Model Work Health and Safety Code of Practice for Mining - Public Comment Response Form

Individual/Organisational name: NEWCREST MINING LIMITED

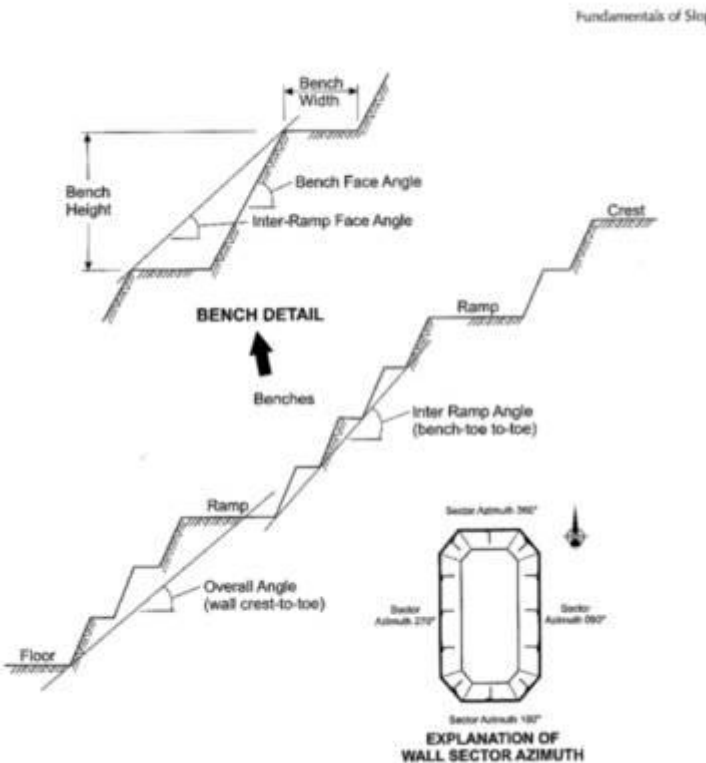
2.1 (7)	<p>The Slope Terminology needs updating to the industry terminology stated in Guidelines for Open Pit Slope Design: Read, 2009. Newcrest follow this standard in Inter Ramp Angle definition as “ The line of the Bench toes”. It is suggested that the diagram be updated to Figure 1.3, p5 as shown below:</p>  <p>Figure 1.3: Pit wall terminology</p>
